RS-12-043

Braidwood Station, Units 1 and 2
Facility Operating License Nos. NPF-72 and NPF-77
NRC Docket Nos. STN 50-456 and STN 50-457

Byron Station, Units 1 and 2
Facility Operating License Nos. NPF-37 and NPF-66
NRC Docket Nos. STN 50-454 and STN 50-455

Subject: Additional Information Supporting Request for License Amendment Regarding
Measurement Uncertainty Recapture Power Uprate

Figure A3.1-1: Byron Station Typical Alden Test Laboratory Pipe Configuration

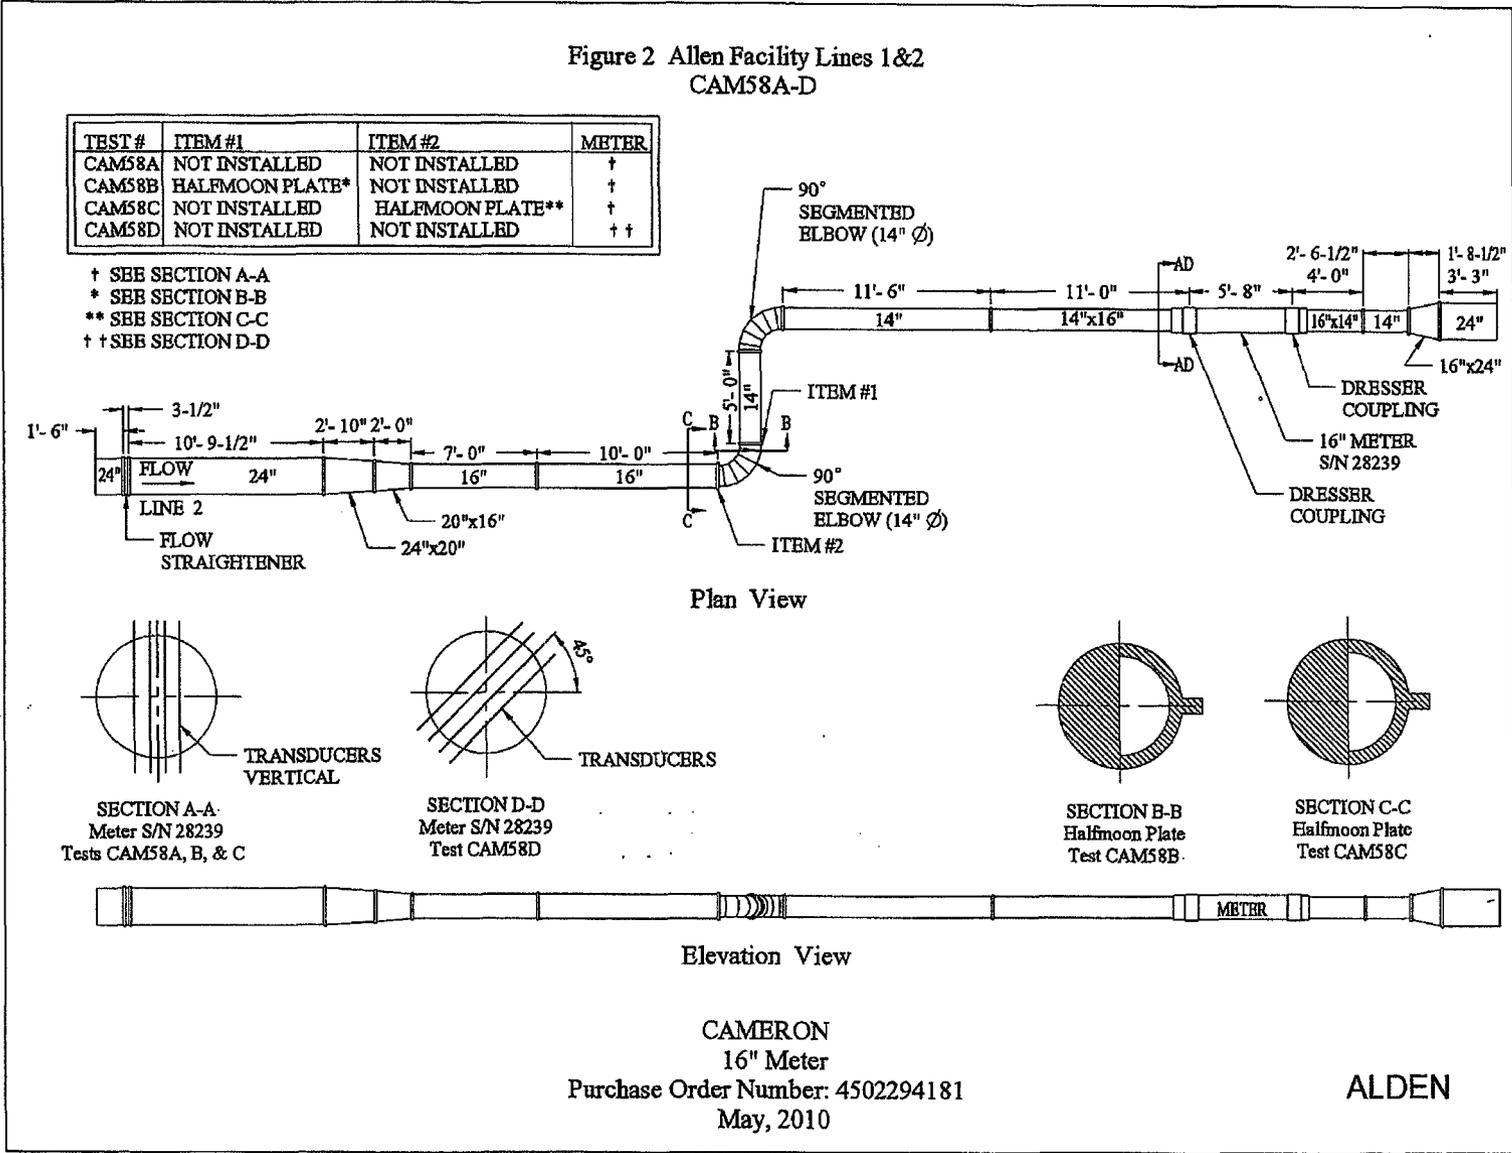
Test fidelity, such as test versus planned plant configuration, test variations to address configuration differences, and potential effects of operation on flow profile and calibration, should be addressed on a plant-specific basis. Applicant requests must provide a comparison of the test and plant piping configurations with an evaluation of the effect of any differences that could affect the UFM calibration. Further, sufficient variations in test configurations must be tested to establish that test-to-plant differences have been bracketed in the determination of UFM calibration and uncertainty. The turbulent flow regimes that exist when the plant is near full power result in limited upstream flow profile perturbation from downstream piping. Consequently, the effects of downstream equipment need not be considered for normal CheckPlus operation provided changes in downstream piping, such as the entrance to an elbow, are located greater than two pipe diameters downstream of the chordal paths. However, if the CheckPlus is operated with one or more transducers out of service, the acceptable separation distance is likely a function of transducer to elbow orientation. In such cases, if separation distance is less than five pipe diameters, it should be addressed. Therefore the staff requests the licensee to provide downstream distances from the ultrasonic flow meter (UFM) to the next non-straight pipe component at the Alden labs test setup to verify their applicability to the in plant setup.

Figures A3.1-1 and A3.1-2 provide diagrams of the Alden Laboratory test piping configuration typical for Byron and Braidwood Stations, respectively. There were no downstream elbows included in the test configuration. Attachment 11 of the Measurement Uncertainty Recapture (MUR) License Amendment Request (LAR) (Reference A3-1) provided the typical in-plant piping configuration; the closest elbow is greater than five pipe diameters (approximately 30-feet) downstream of the LEFM spool piece.

Figure A3.2-1: Byron Unit 1 Feedwater Flow - Venturi Flow Minus LEFM Flow (per Loop)

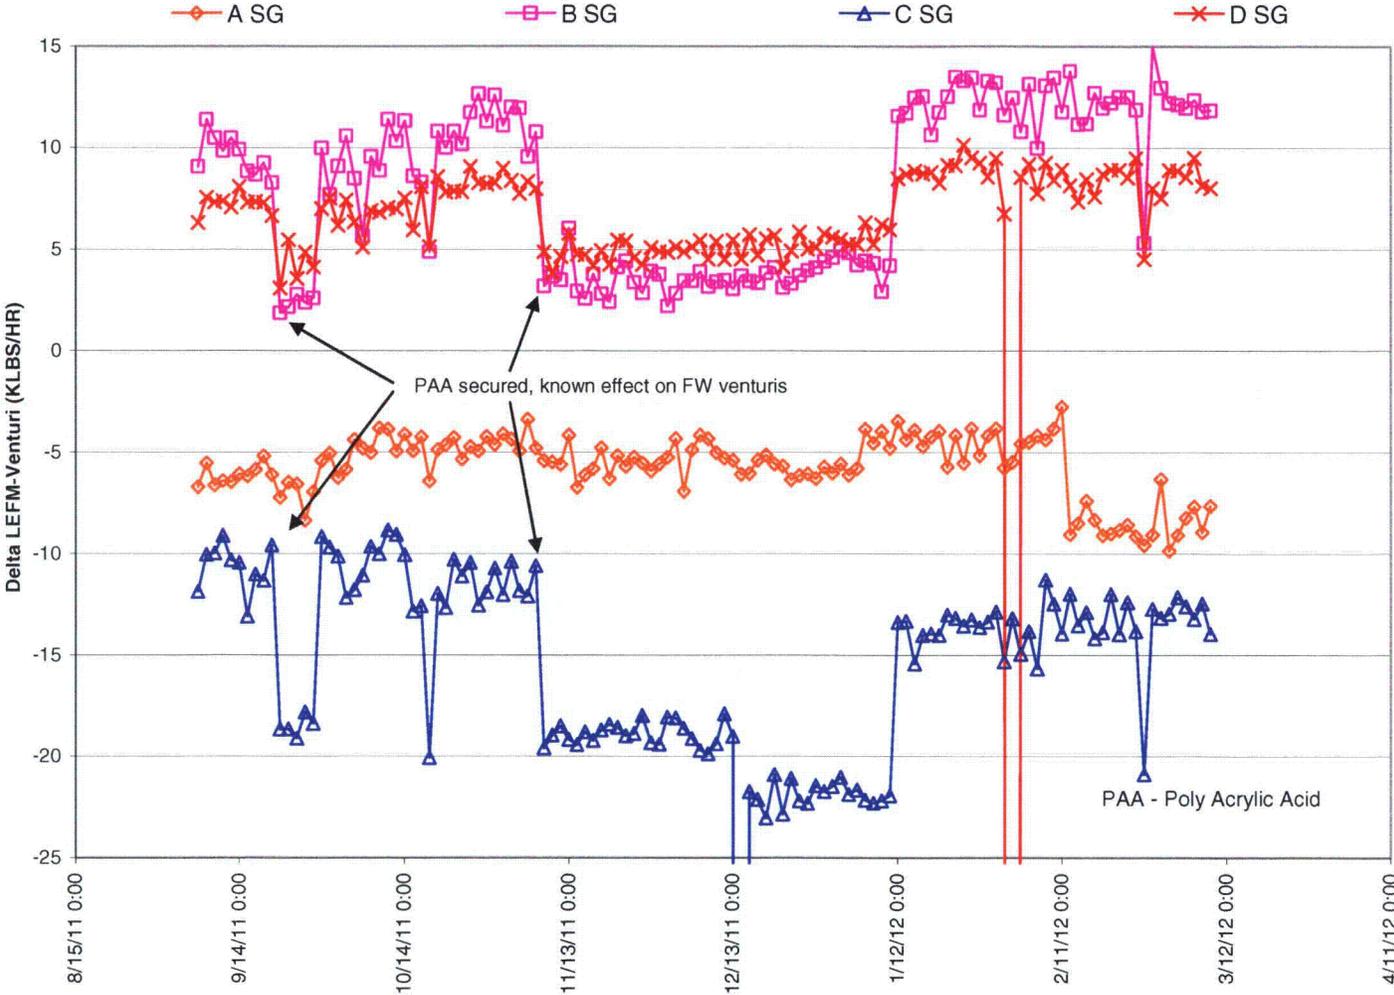
Each applicant for a power uprate must conduct an in-depth evaluation of the UFM following installation at its plant that includes consideration of any differences between the test and inplant results and must prepare a report that describes the results of the evaluation. This should address such items as calibration traceability, potential loss of calibration, cross-checks with other plant parameters during operation to ensure consistency between thermal power calculation based upon the LEFM and other plant parameters, and final commissioning testing. The process should be described in written documentation and a final commissioning test report should be available for NRC inspection. Therefore the NRC staff requests the licensee to provide a summary of the data comparing the LEFM Checkplus operating data to the Venturi data for the past 6 months to verify consistency between thermal power calculation based on LEFM and other plant parameters.

The data provided is derived by taking flow data and averaging over a two hour period. One two hour average is collected every 36 hours and reported in the files on the accompanying CD and graphed on Figures A3.2-1 through 6. Figures A3.2-1, 3 and 5 show the difference between the venturi and the LEFM flows for each of the feedwater line flows for Byron Units 1 and 2, and Braidwood Unit 2, respectively. Figures A3.2-2, 4 and 6 show a comparison of the total feedwater flow between the venturis and LEFM for Byron Units 1 and 2, and Braidwood Unit 2, respectively.
